Job Sheet 209033

Part Name: LH Wiper Deflector

WORK ORDER NON-CONFORMANCE / ROUTE UPDATE

Subject: 649.5111/649.5112 Deviation acceptable?

SECTION B-B

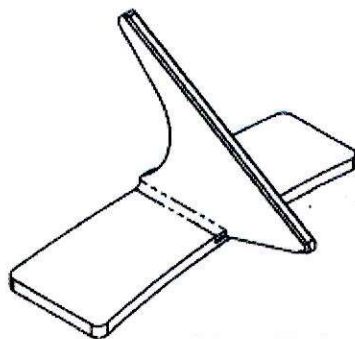
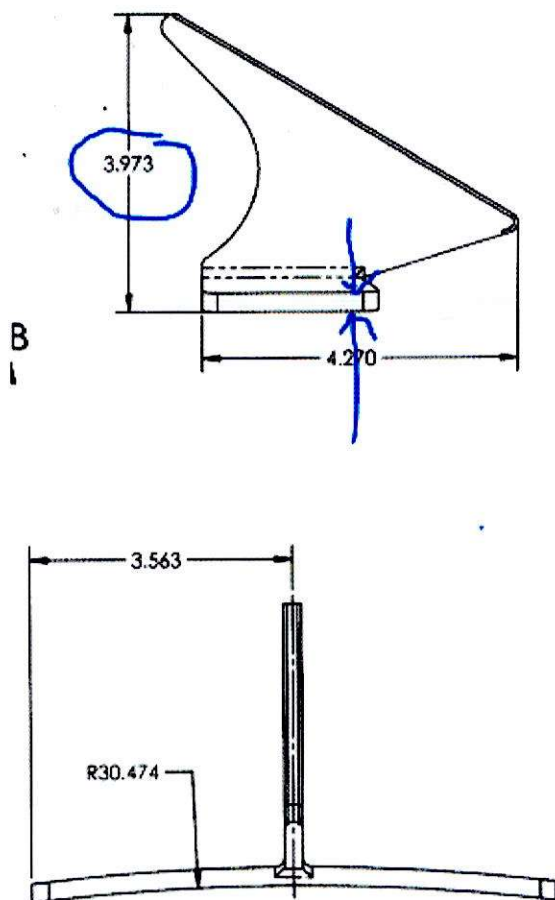
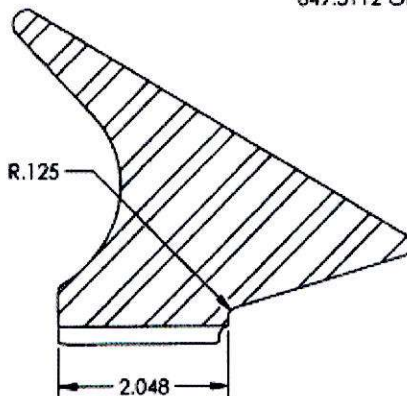
We have a few parts that came in under size during manufacturing, .250" not dimensioned came in at .234" therefore affecting the 3.973" overall height coming in at 3.957".

The problem is now resolved and parts are per dwg, 5 parts total were affected.

Is this acceptable?

This is acceptable.
